PCN – Product Change Notification

PCN-A-111019

PCN Topic: 24" S1 panel (1920x1200) will be replaced by 24" A1 panel (1920x1080).

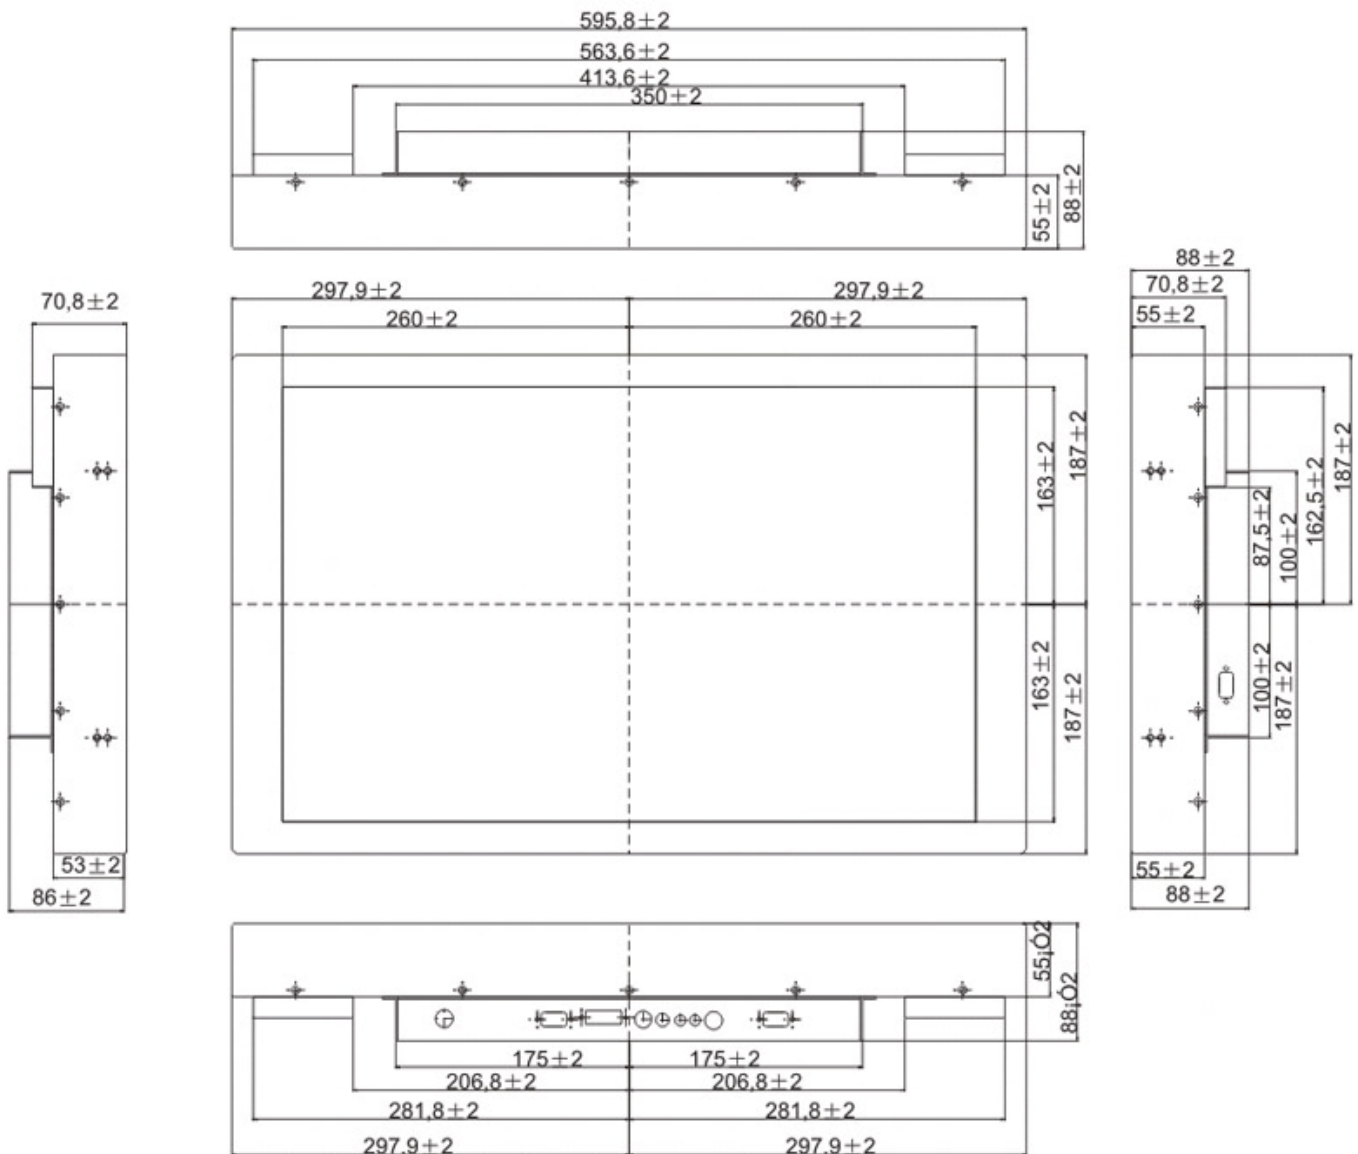
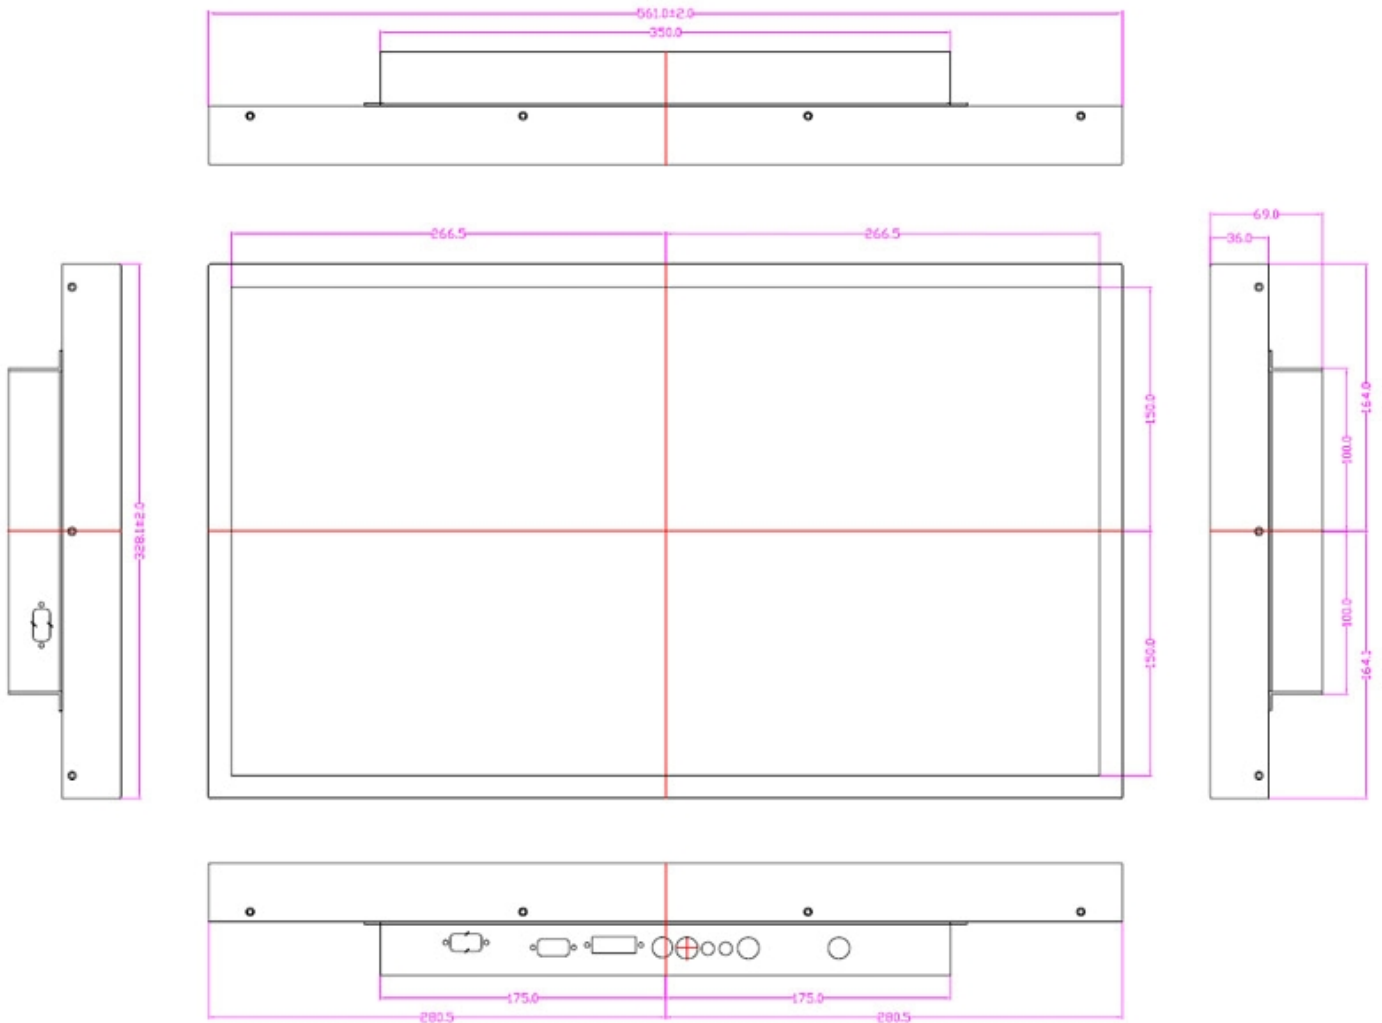
The 24" S1 panel (1920x1200) is replaced by 24" A1 panel (1920x1080):

The dimension of **Chassis** mechanical will change from 595.8 X 374X 88 mm to 561 X 328.1 X 69 mm.

The below pictures show the example of how the new mechanic differ from Original one.
